RE: Riverpark Draft EIR

RE: Comments on Riverpark Project Draft EIR

El Rio West Neighborhood (1) (ERW)

FIGURE 2-27

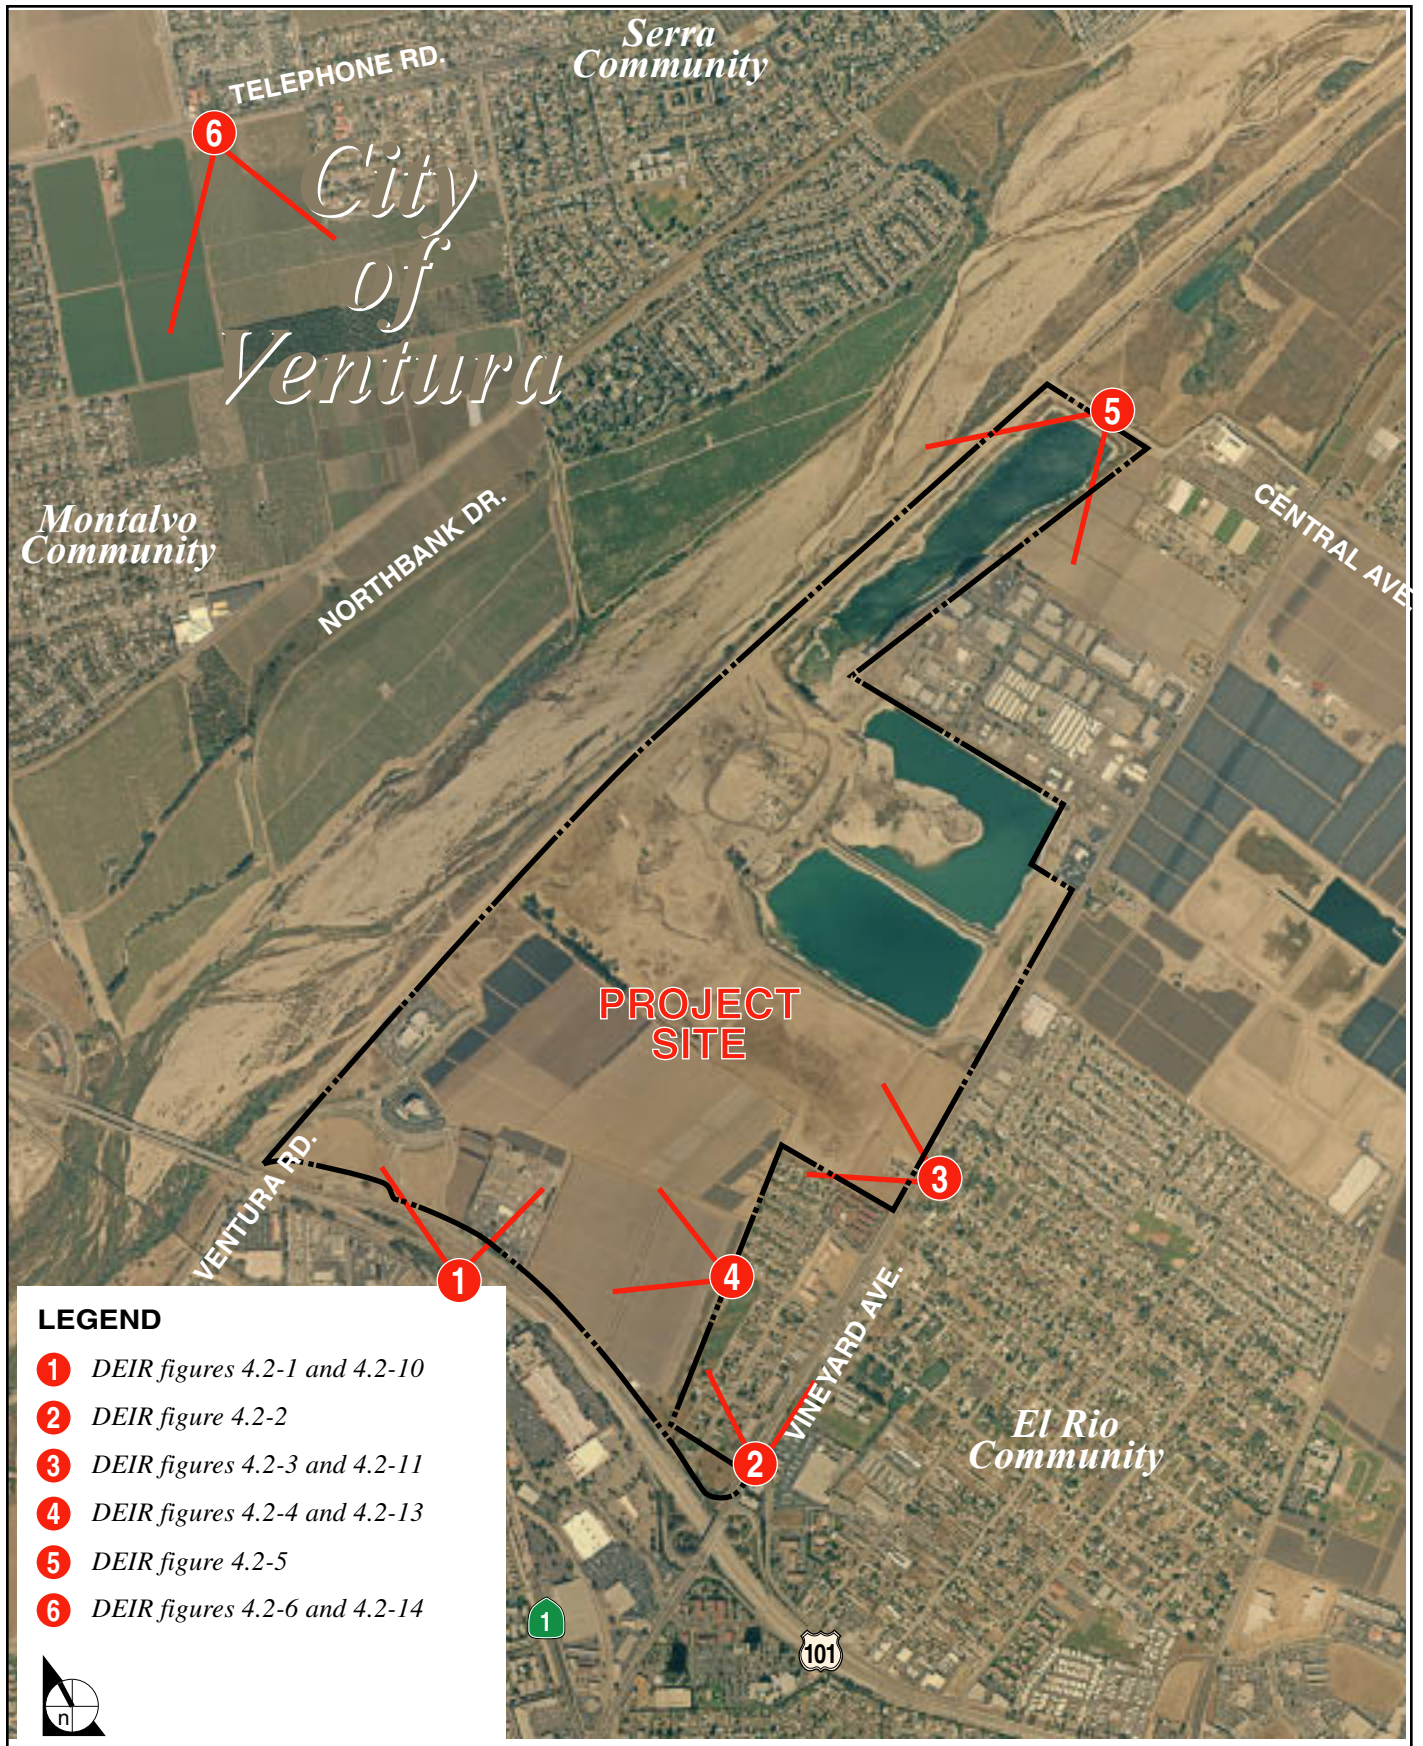
Aesthetics - The Aesthetics Section would benefit from a readable map which identifies the streets and the locations from which viewshed perspectives were taken. It is difficult, even for those familiar with the area, to ascertain exactly where these photographs were taken. New streets depicted in these photographs should be named.

Figure 2-27 is provided on the following page showing the locations from which the photographs provided in Section 4.2 are taken. Figure 4.2-10 is on Oxnard Boulevard and is represented in **Figure 2-27** as Viewing Location 1 indicated on entry to project extension. Figure 4.2-11 is of the intersection of Santa Clara River Boulevard and Vineyard Avenue and is represented as Viewing Location 3 in **Figure 2-27**.
